**Re: Route 66 Veterinary E.R. & Critical Care Center**  
**3601 Central Ave NE**  
**Request for Certificate of Occupancy**  
**Transportation Development Final Inspection**  
Engineer's/Architect's Stamp dated 3-19-21 (K17D064)  
Certification dated 11-24-21

As-Built Traffic Circulation layout  
11/8/21

Re: **Permanent Certificate of Occupancy for  
Route 66 Veterinary Emergency & Critical Care Center  
3601 Central Ave NE  
Albuquerque, NM 87108**

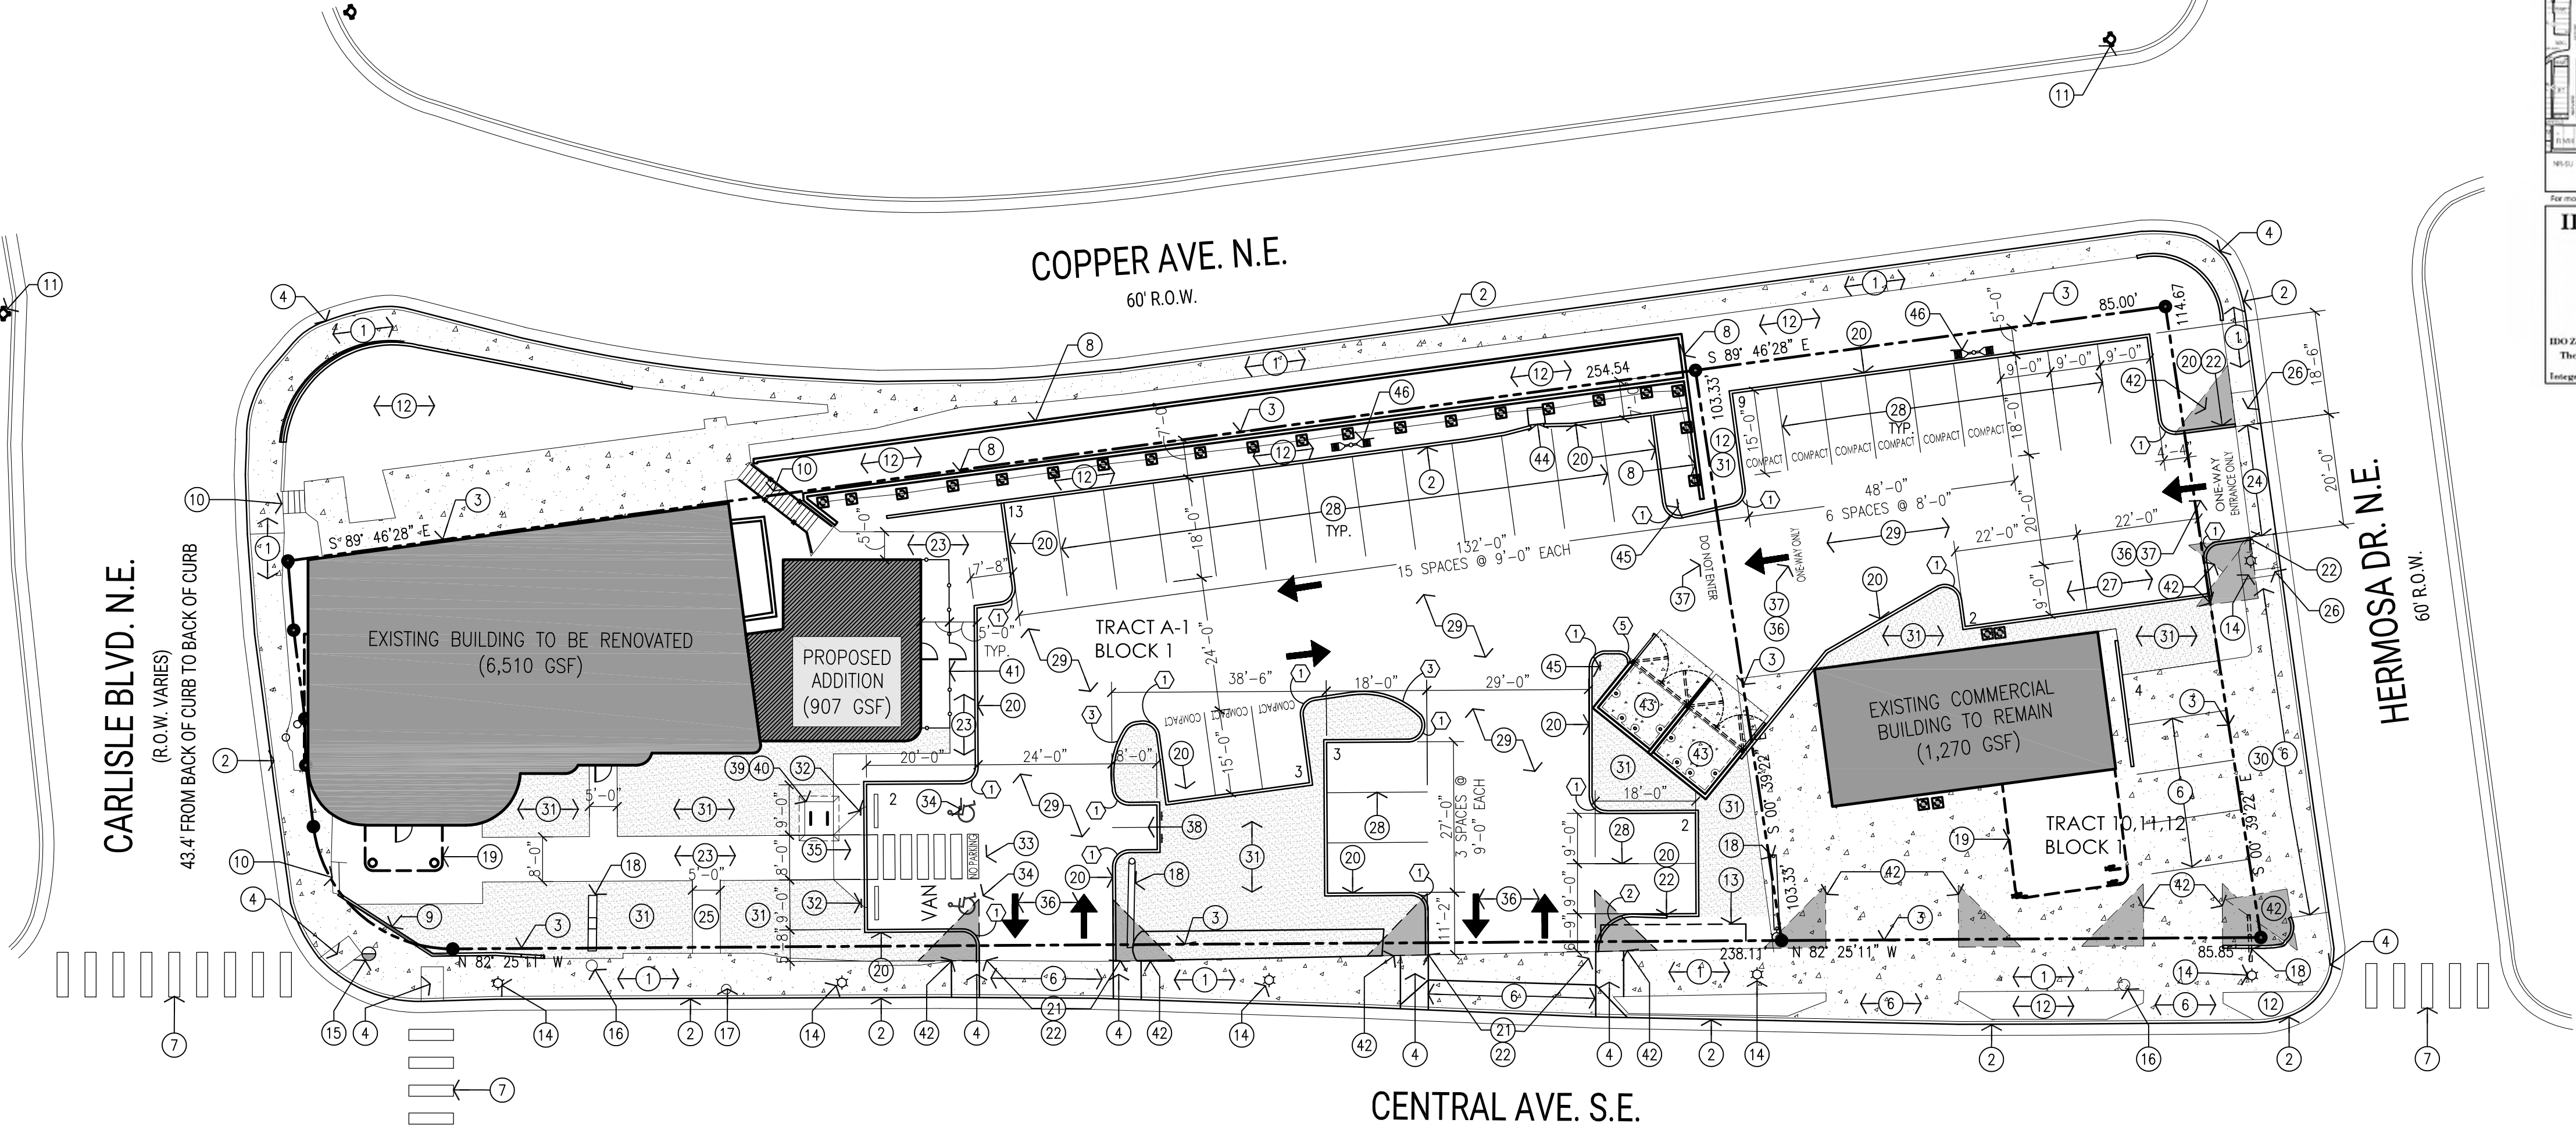
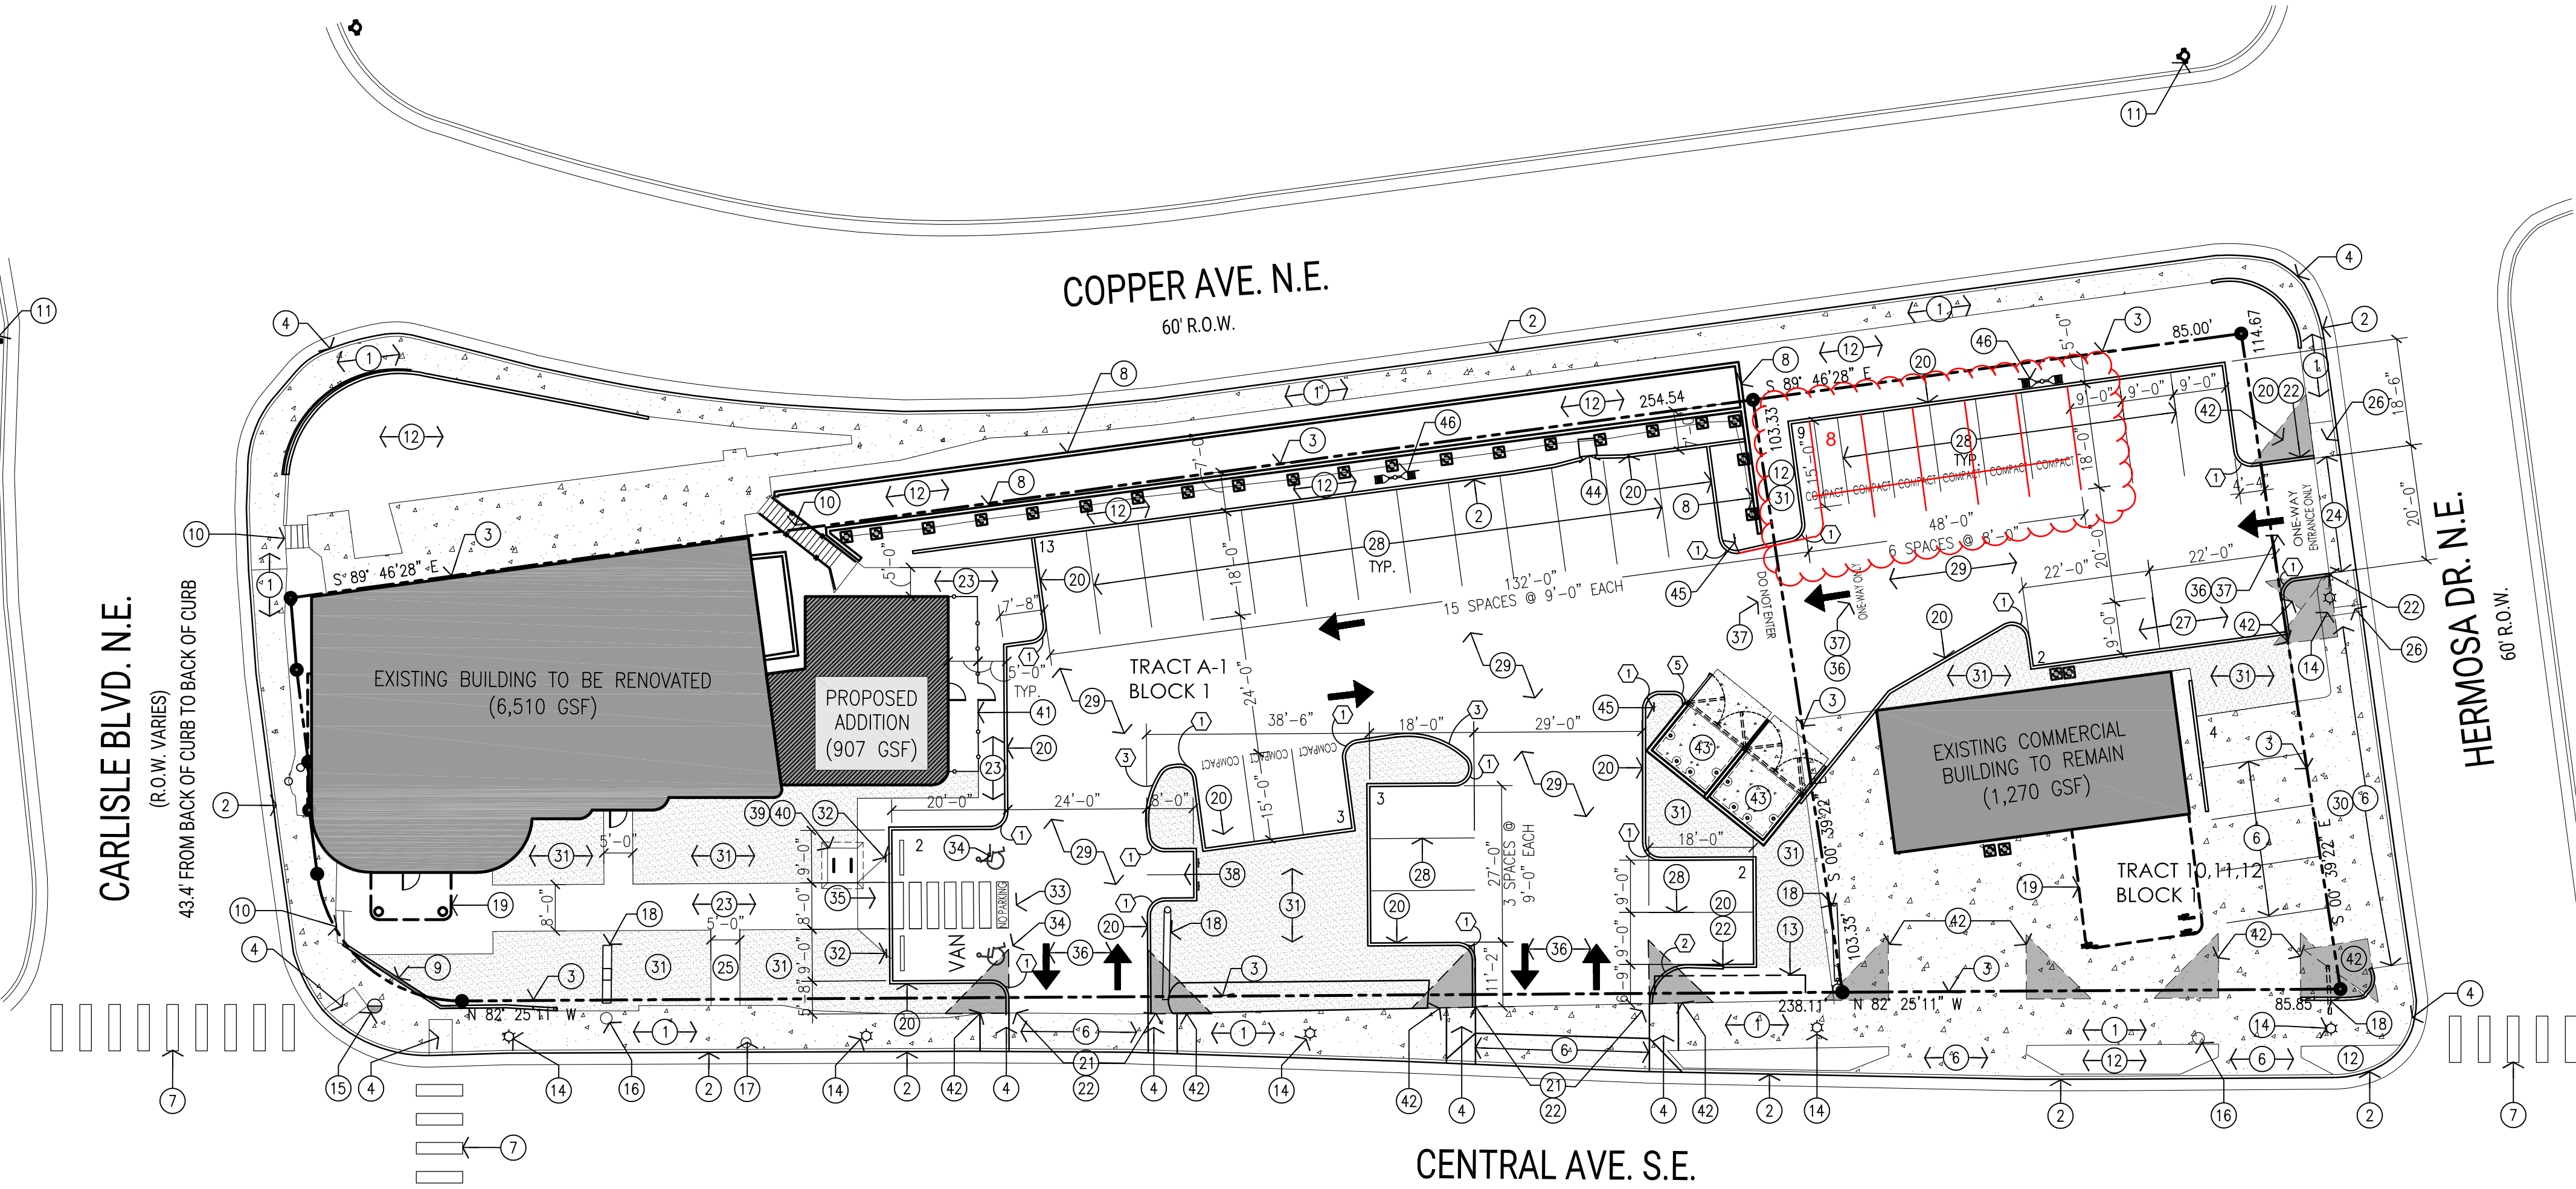
I, Doug Heller, NMRA with Mullen Heller Architecture P.C., hereby certify that this project is in substantial compliance with and in accordance with the design intent of the approved Traffic Circulation Layout (Permit #BP-2021-12043). The attached As-Built Traffic Circulation Layout shows "redlined" revisions made to the site plan per construction coordination.

The construction of the sitework matches the approved permit drawings with one exceptions, which include:

- One space in the northeast row of 9 parking spaces was omitted to accommodate an existing mature tree. This row of 8 parking spaces are all now standard-size in lieu of the 'compact' spaces as approved. The reduction in parking spaces does not affect the required parking as the site plan has an excess of parking. The 'Parking Provided' calculations have been adjusted accordingly.
- Landscaping is complete throughout the site and barricades have been removed.
- Sidewalk repairs are complete along Copper Ave.
- All parking and directional signage which was missing as part of the previous submittal has been installed.

SPACES PROVIDED:  
REGULAR SPACES: 27-32 = 30 SPACES  
COMPACT SPACES: 3-3 = 3 SPACES  
ADA SPACES: 2 = 2 SPACES  
TOTAL: 35 SPACES
